Belmore Road Ramps – Review of Environmental Factors

Submissions Report

Roads and Maritime Services | February 2018

Construction site / compound proposed access and recorded threatened species **Figure 5**

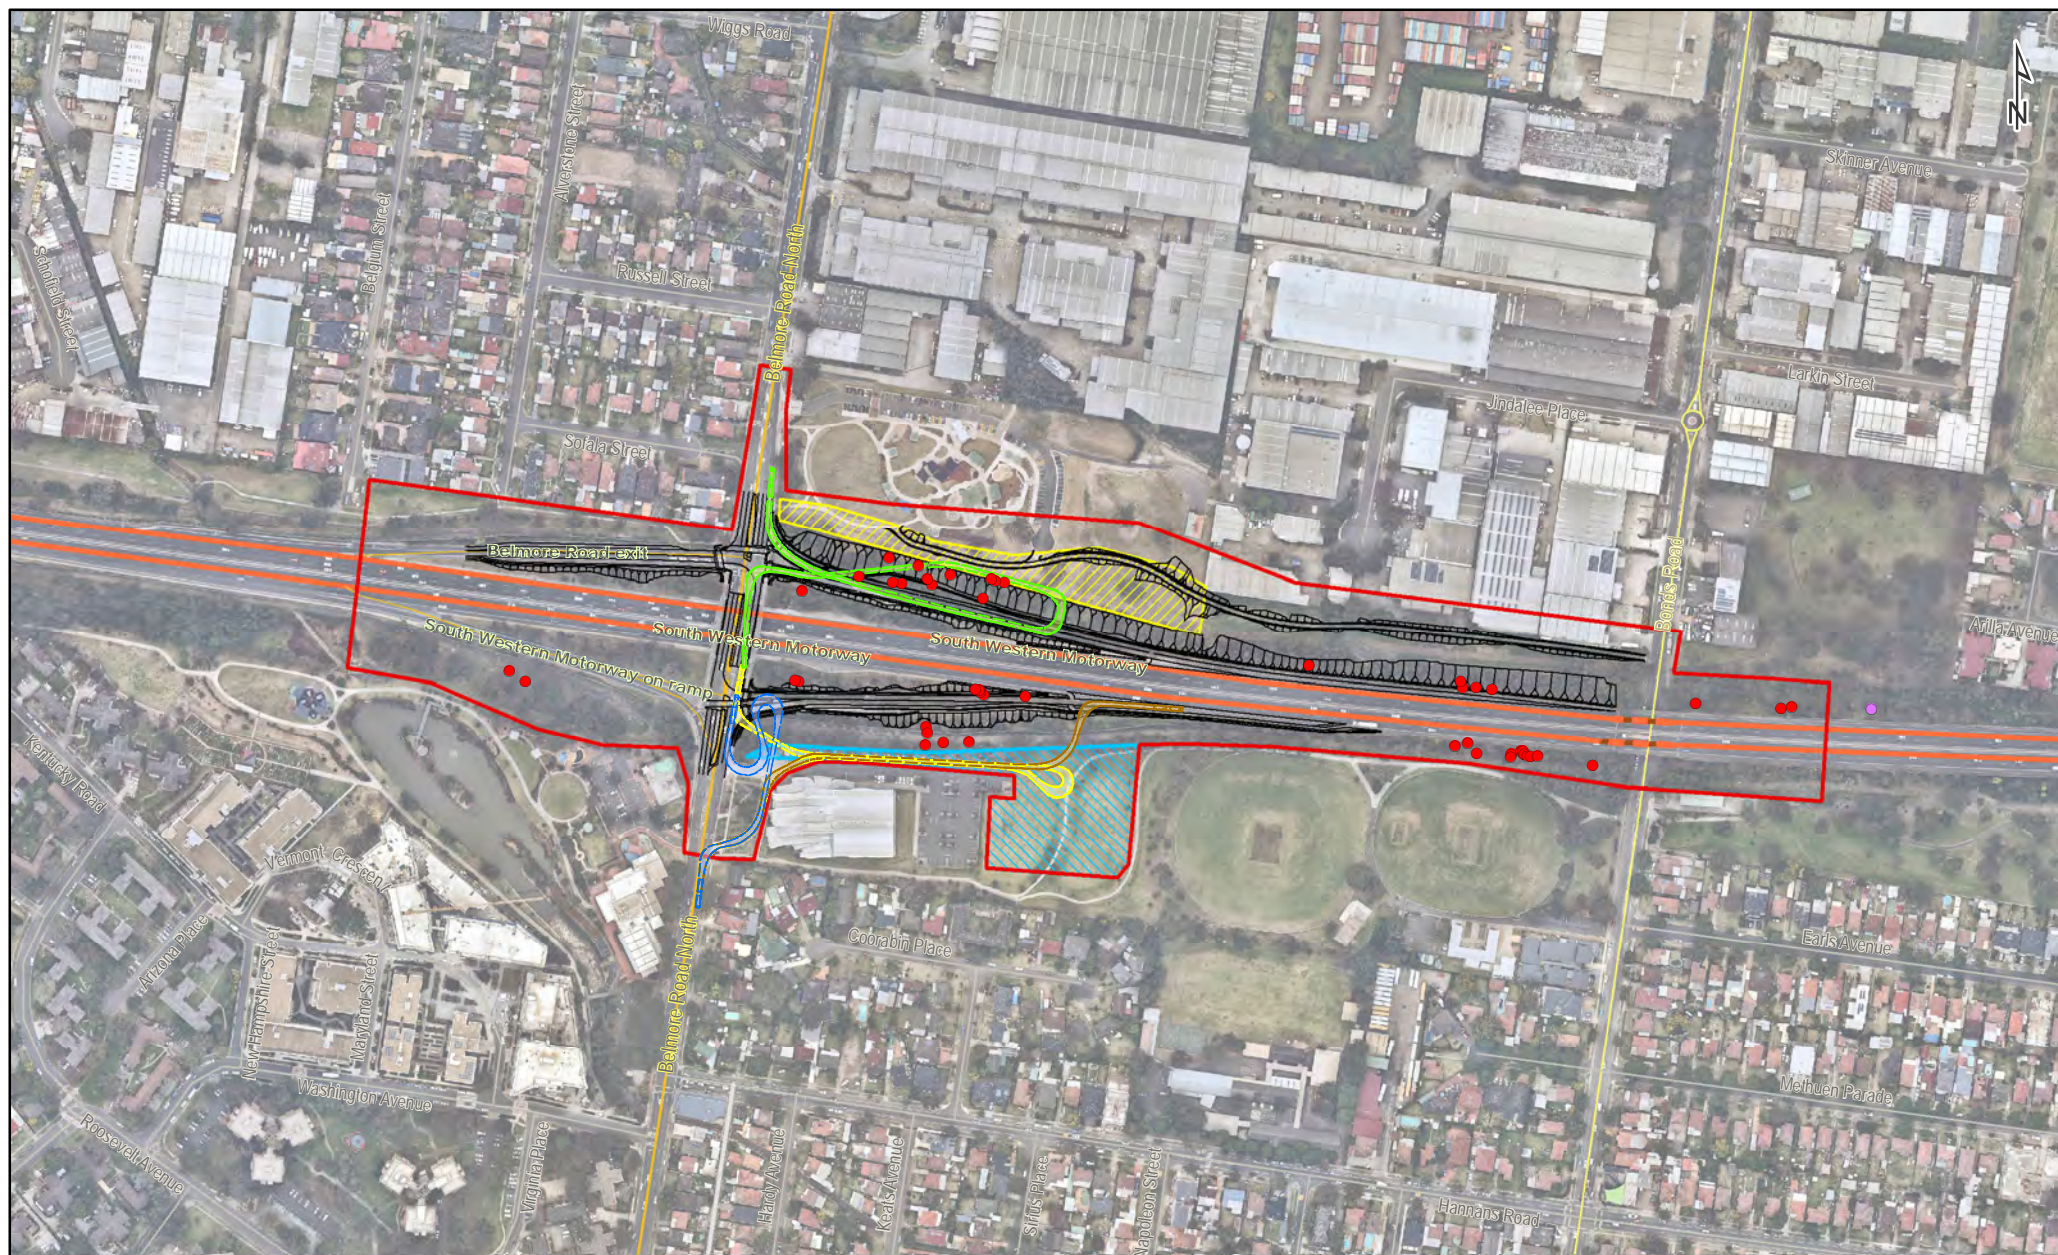
At meetings held between CBCC and Roads and Maritime, it was proposed that heavy construction vehicle access to Rotary Park would be through the agreed licensed/leased area only, and not via the existing park entrance and car park. This will provide a clear separation of public and heavy construction vehicle access areas. The car park would only be used by light construction vehicles as an alternate access to the construction site compound. No construction vehicles will park within the car park. This will be discussed further in consultation between Roads and Maritime and CBCC.

An option has also been discussed between CBCC, the DPE and Roads and Maritime to use the area between the proposed road ramps and the existing driveway for construction vehicle access/egress to the sites. This would allow a complete separation of public and construction vehicles. RMS will investigate these options further and will advise CBCC of their feasibility. Proposed access and turning paths are shown in **Figure 5**.
